1.0 GENERAL INFORMATION

This chapter of the draft Safety Evaluation Report (DSER) discusses general information contained in Chapter 1 of the Mixed Oxide Fuel Fabrication Facility (MFFF or the facility) Construction Authorization Request (CAR) (Reference 1.1.3.1). Chapter 1 of the MFFF CAR provides general information about the facility processes and the site. It consists of a general facility description, material flow, and process overview. The objective of this chapter is to familiarize the reader with the pertinent features of the facility and the site.

Figure 1.1-1 MOX Fuel Fabrication Facility Controlled Area Boundary

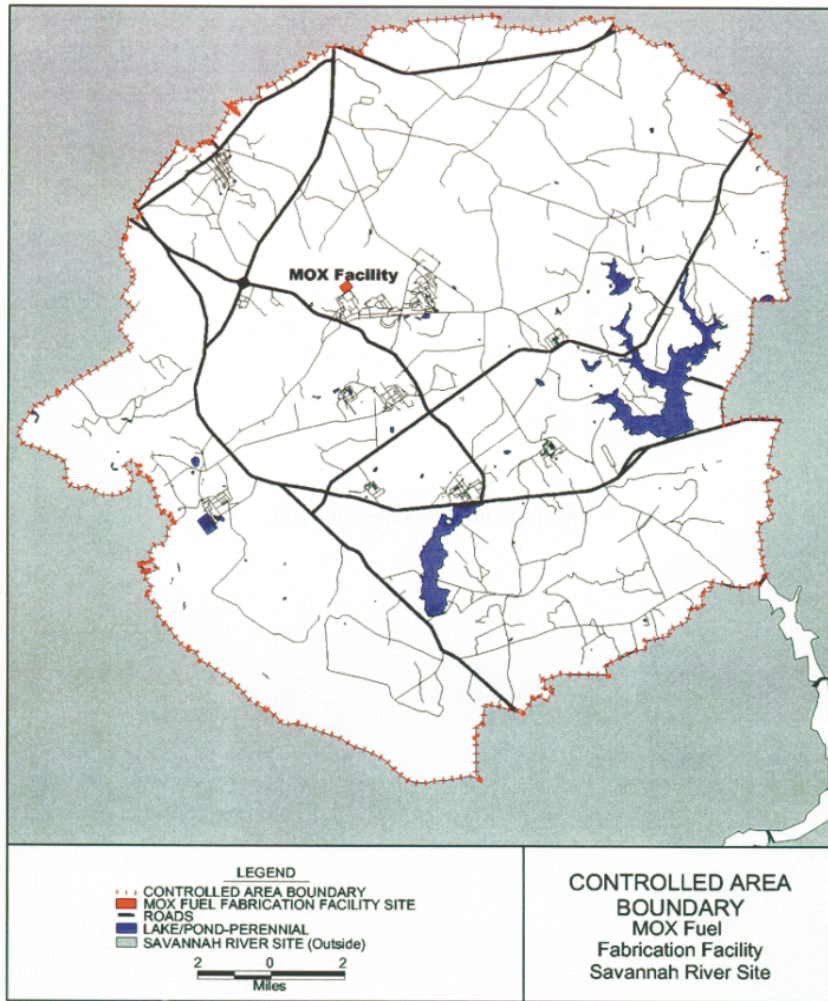
With respect to the controlled area boundary, 10 CFR 70.61(f) requires that the applicant establish a controlled area, as defined in 10 CFR 20.1003. Section 20.1003 of 10 CFR defines the controlled area as an area outside of the restricted area but inside the site boundary, access to which can be restricted by the licensee for any reason. In addition, 10 CFR 70.61(f) states that the licensee must retain the authority to exclude or remove personnel and property from the controlled area. The applicant has chosen the controlled area boundary to be largely coincident with the boundary of DOE’s SRS. It is shown in Figure 1.1-3 in the CAR, which has been reproduced as Figure 1.1-1 in this DSER.

This commitment is acceptable to the staff for construction authorization because it meets the requirements of the regulation at section 70.61(f) with respect to establishing a controlled area. However, the staff conditions its final approval of this controlled area designation upon the conclusion of the staff's review of the applicant's protocol agreement with DOE-SRS, including the augmented DOE radiation protection training program information. The staff will review this as part of the license application review.

The staff recognizes that roads used by members of the public traverse the controlled area. This situation was considered during the 10 CFR Part 70 rulemaking. In Reference 1.1.3.2, the Commission stated that use of the integrated safety analysis to determine the risks to individuals who make infrequent visits to the controlled area would need to consider second-order effects such as the probability of the individual being present at the time that the unlikely or highly unlikely accident occurred. The Commission concluded that this level of detail is unnecessary to accomplish the purpose of the Part 70 rule (i.e., to document and maintain the safety basis of the facility design and operations). The Commission also concluded that the regulations of 10 CFR Part 20 afford an adequate level of protection to these individuals.

The staff concludes that the applicant's location of the controlled area boundary meets the requirements in 10 CFR 70.61(f). The staff will review whether the applicant meets its remaining 10 CFR 70.61(f) commitments as part of the review of the license application.
